**Proposed Ground Floor Plan**

client	Extension to Dining and Changing Rooms-		
title	Proposed Ground Floor Plan		
	Working Drawing		
scale:	1:50 @ A1	date:	Nov 04
drawing no	DIN-01	amendment	A

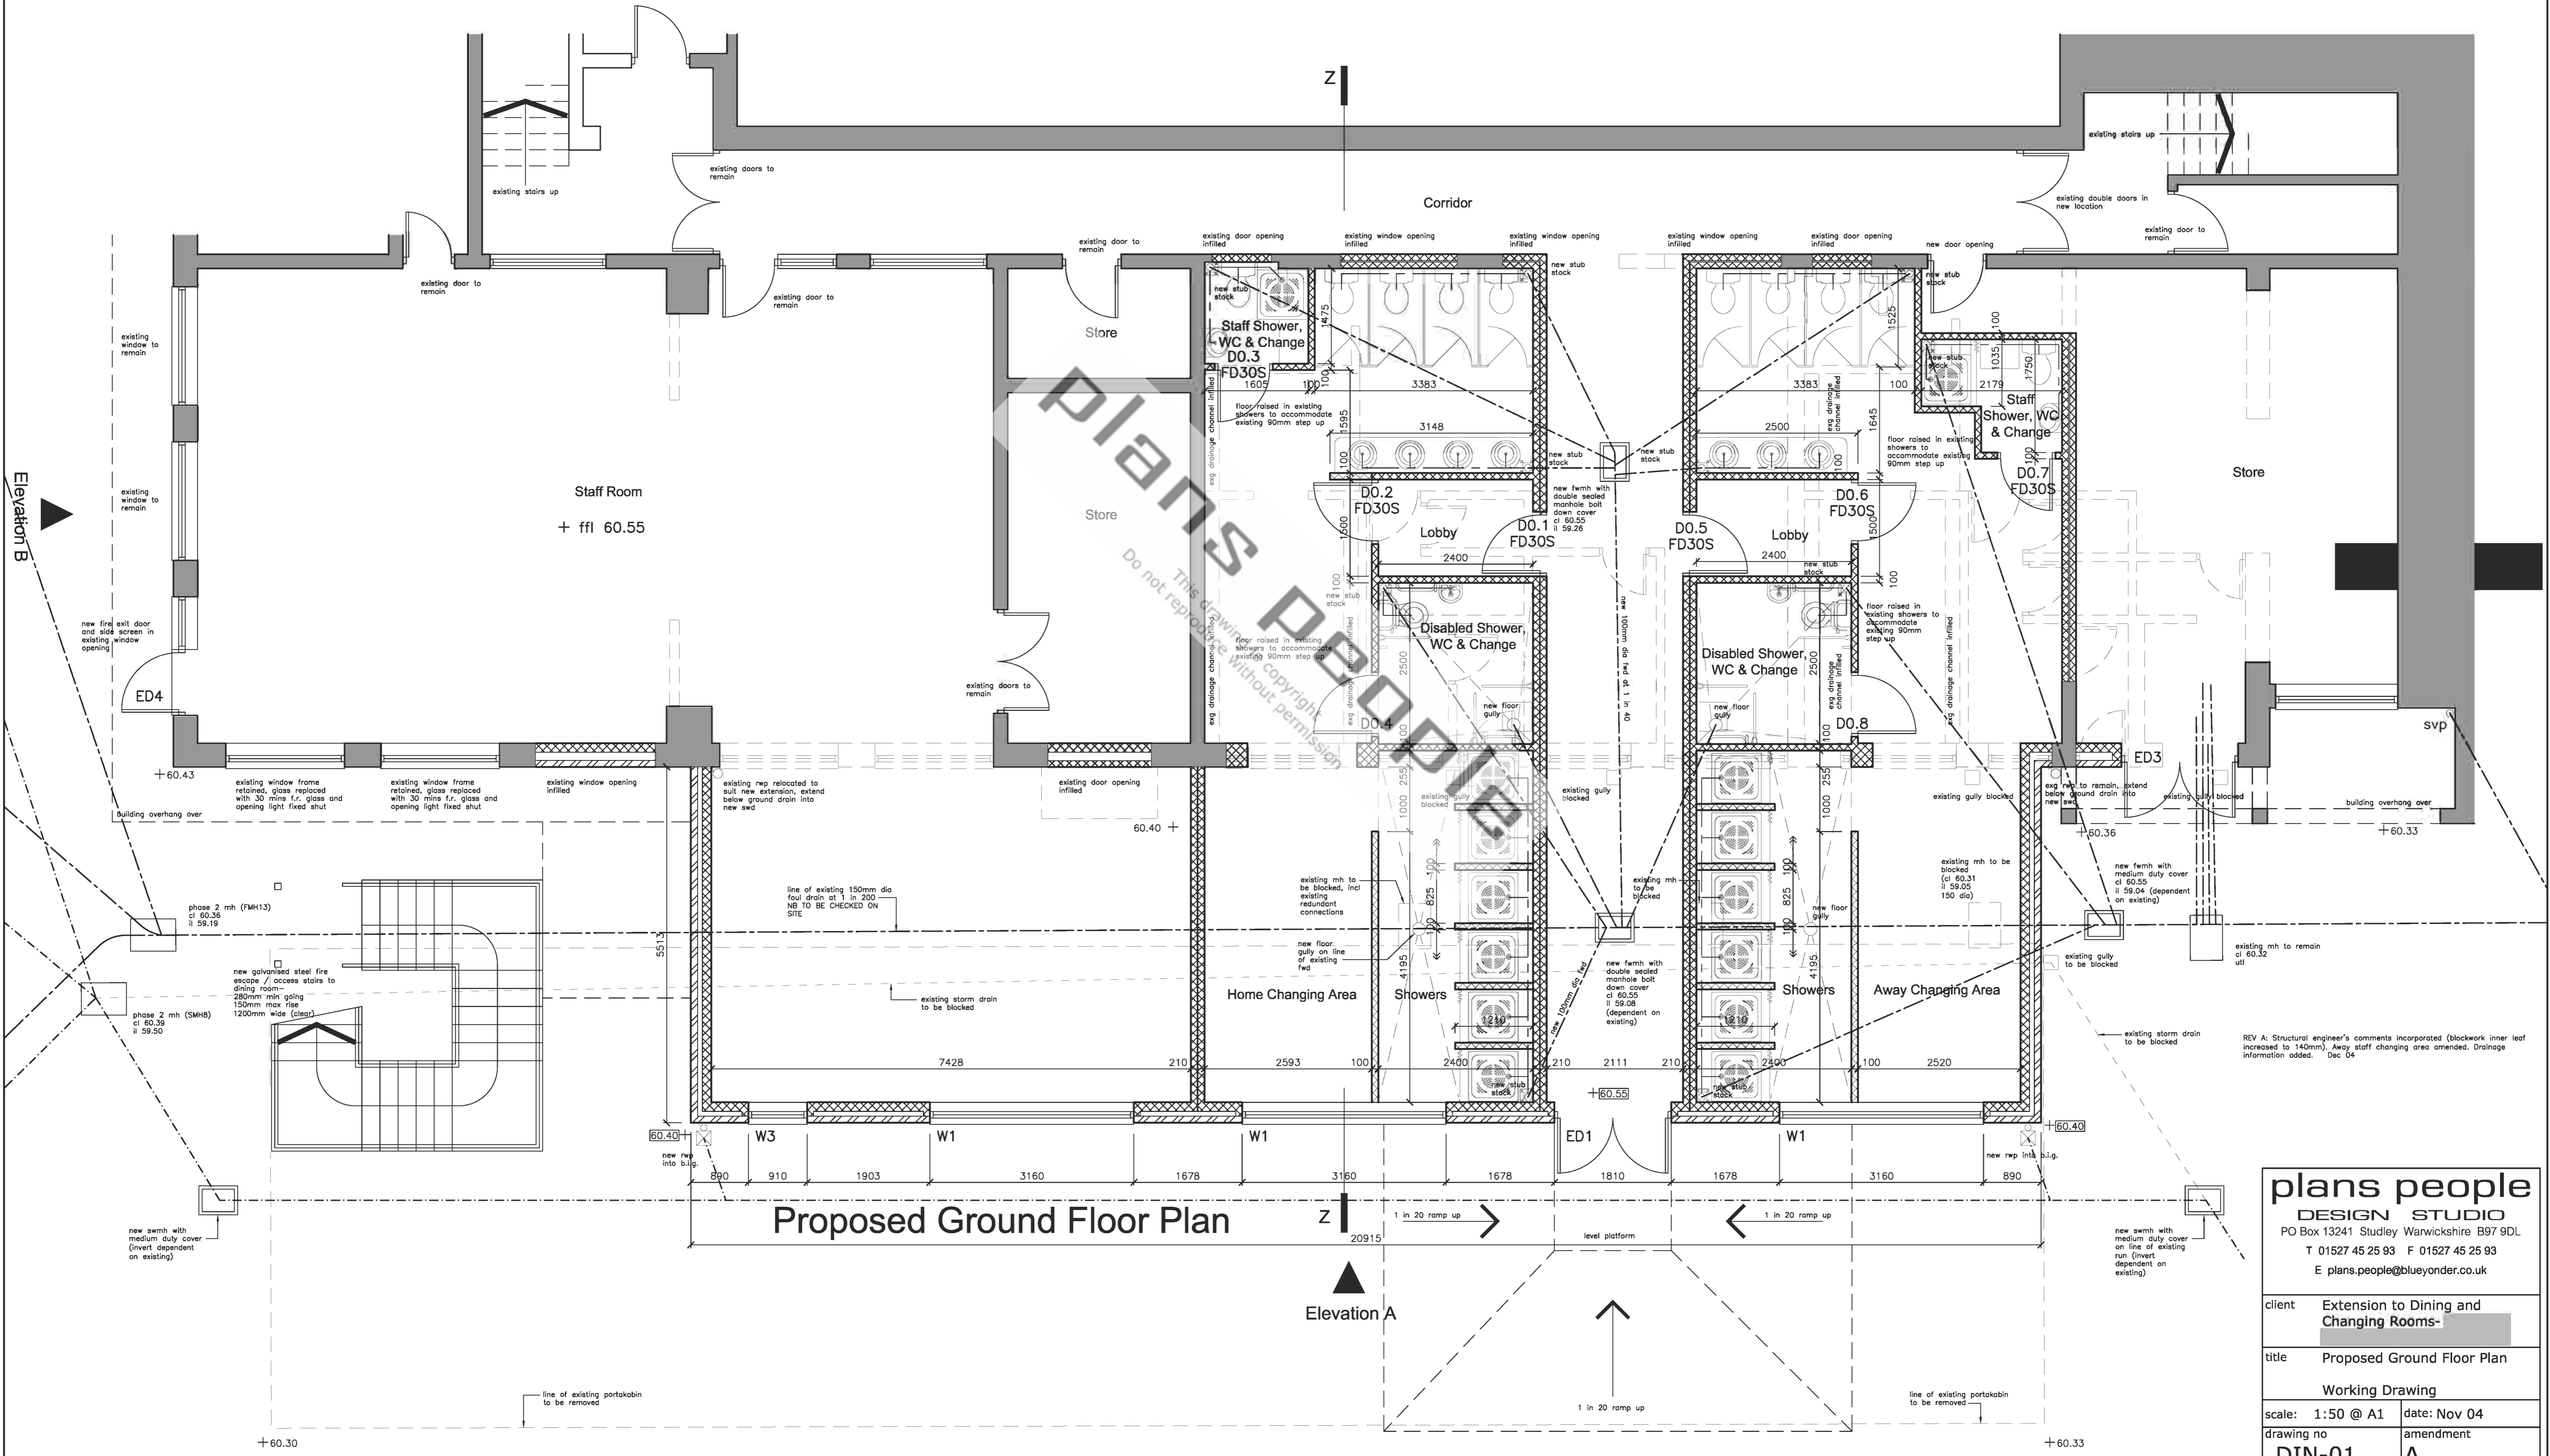
REV A: Structural engineer's comments incorporated (blockwork inner leaf increased to 140mm). Away staff changing area amended. Drainage information added. Dec 04
